# San Francisco International Airport Shoreline Protection Program

BCDC ECRB Meeting  
September 25, 2024

# Agenda

Base Station Settlement (2011-2022) with Forecast to 2085

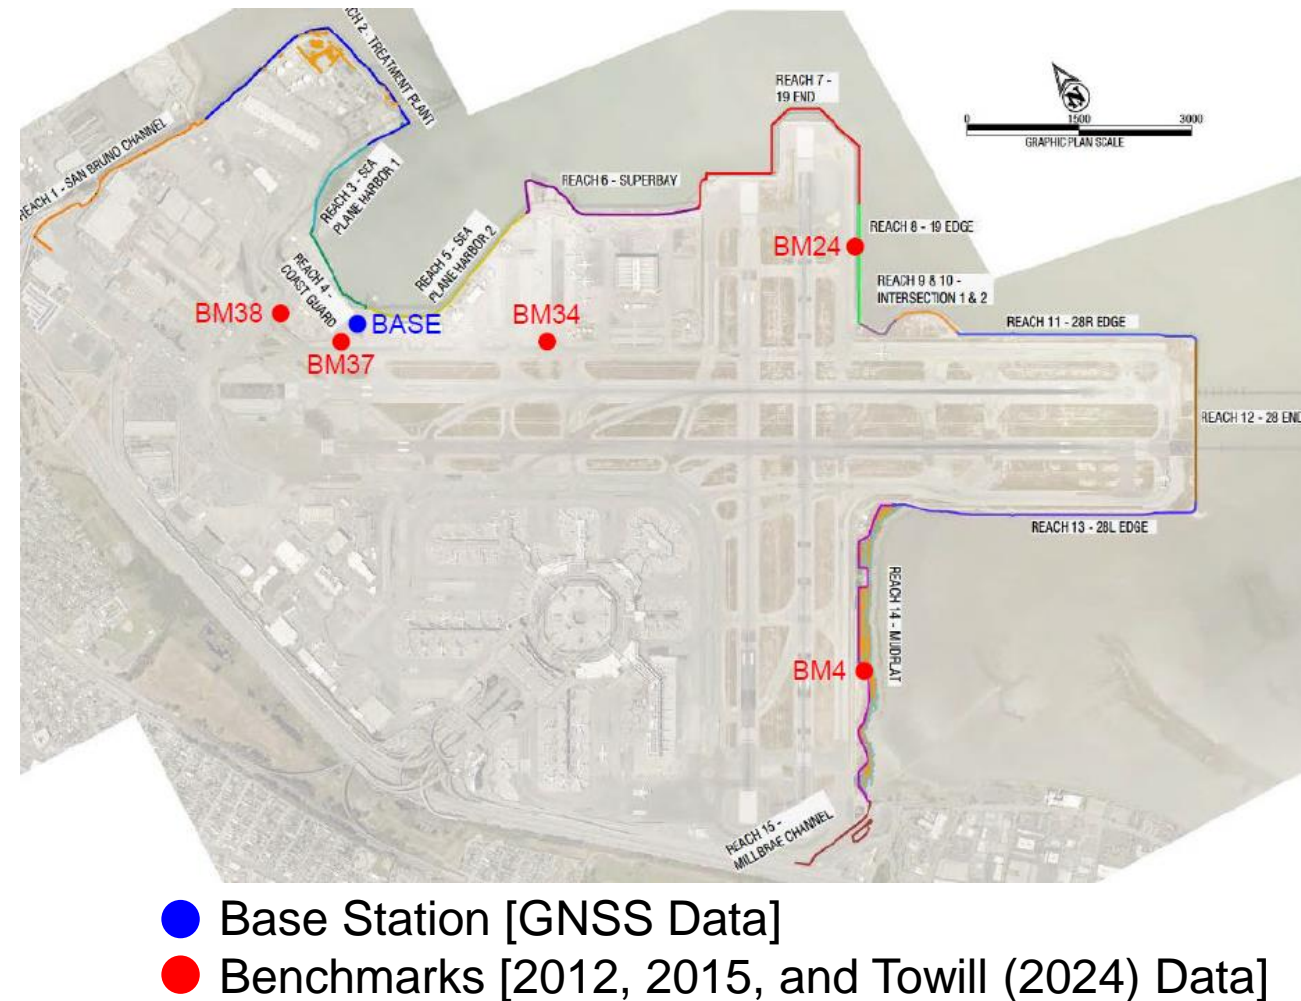
**ECRB-9:** Discuss the expected amount of land subsidence that could cause the proposed wall to sink over the life of the project.

- Global Navigation Satellite System (GNSS) elevation data collected weekly at the SFO base station between 2011 and 2022.
- Annual survey data in 2012 and 2015 for numerous benchmarks around SFO. A 2018 data set was reviewed with noted inconsistencies, and therefore not used.
- Towill (2024) ground validation survey at 151 points around SFO in December 2023, for comparison with USGS 2010 and 2017 LiDAR elevations. LiDAR data was not sufficiently accurate for the purposes of the settlement assessment.

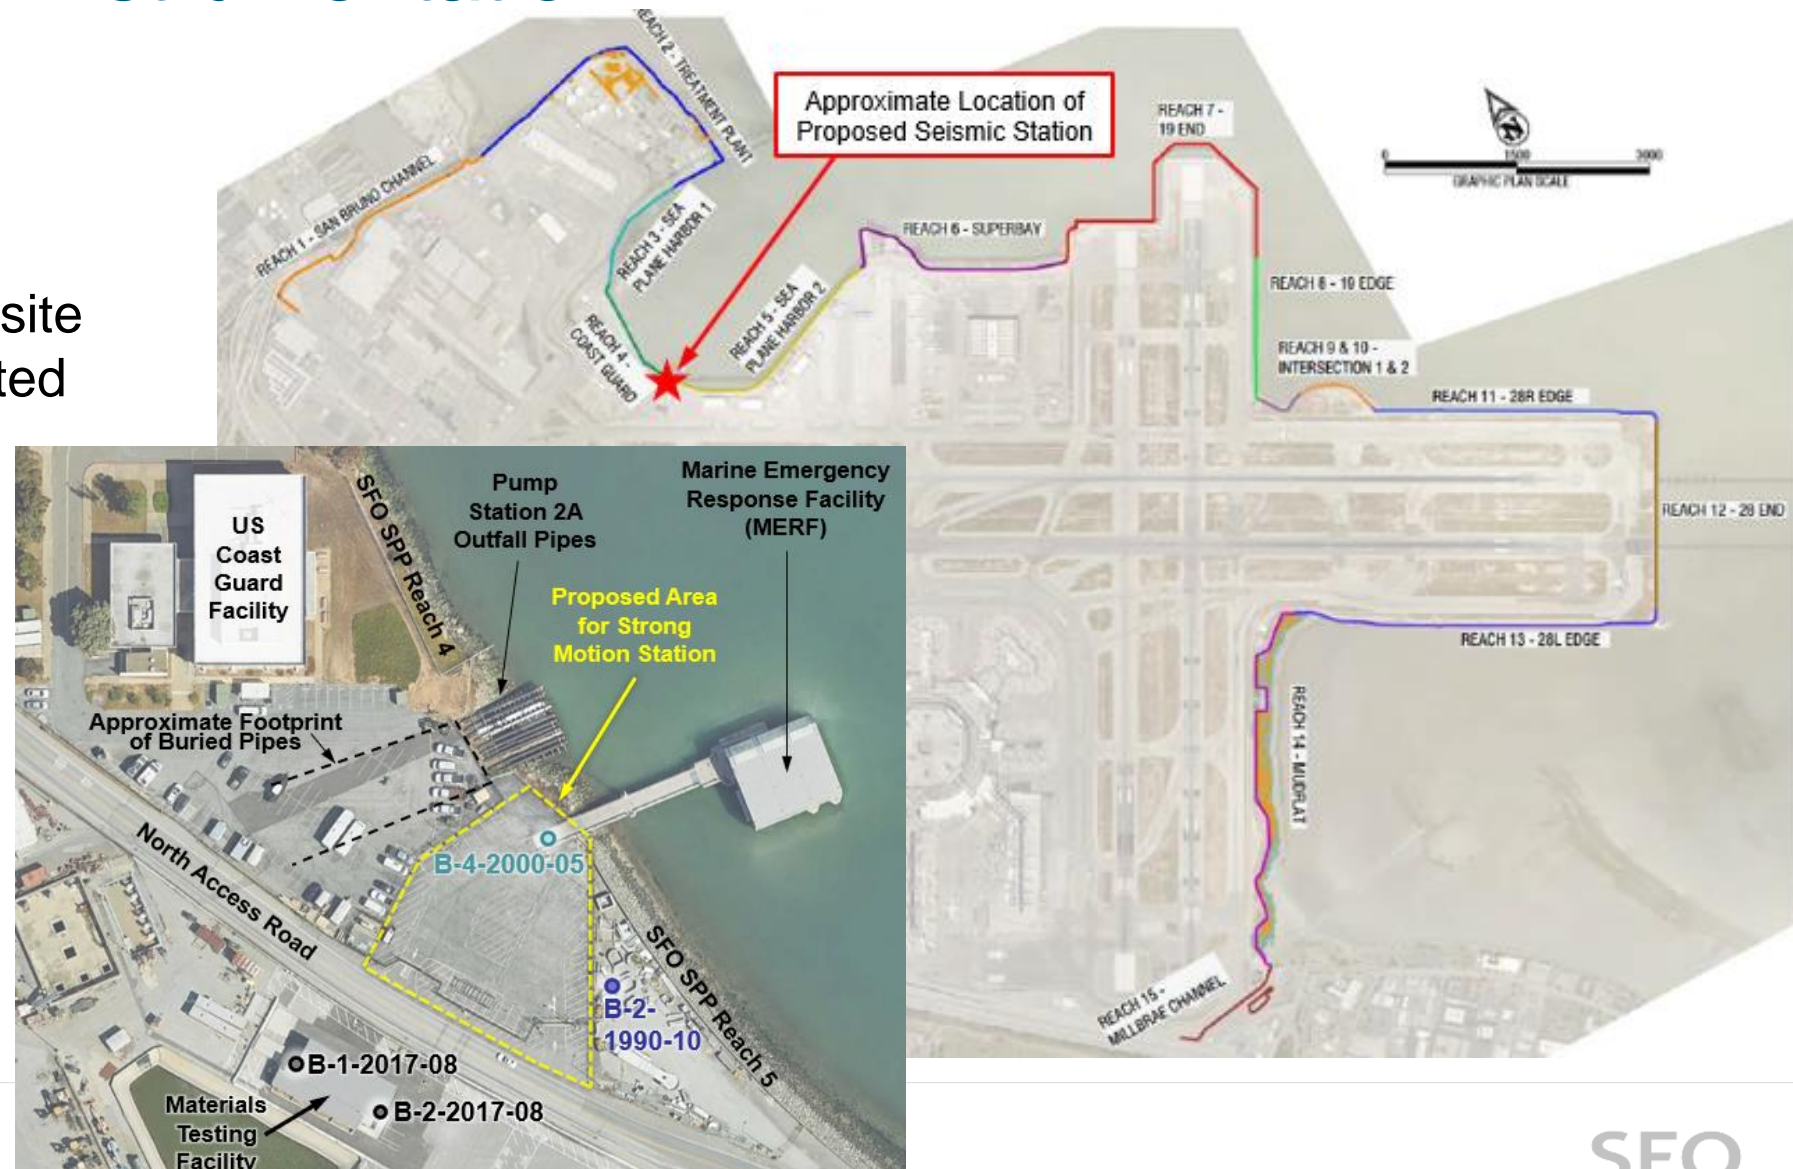
*ECRB-12: After checking in with Hamid Haddadi, the Program Manager of the California Strong Motion Instrumentation Program (CSMIP), provide a draft Seismic Instrumentation Plan with recommended locations for strong motion seismographs to be incorporated into the state's seismic instrumentation network.*

- SFO provided CGS with pertinent SPP design drawings and documents in support of their review process.
- In response to ECRB-12, Geosyntec prepared a memorandum with recommendations for a strong motion instrumentation plan, including:
  - **Station Location**
  - **Equipment**
  - **Site Access Information**
  - **Foundation Layout**
  - **Power Supply**
  - **SFO Point of Contact**
  - **Enclosure Layout**
  - **Communication**
- Recommendations were developed to meet the instrumentation requirement for the SFO SPP with consideration of the BCDC instrumentation process, state instrumentation specifications, and guidelines presented in COSMOS (2001).
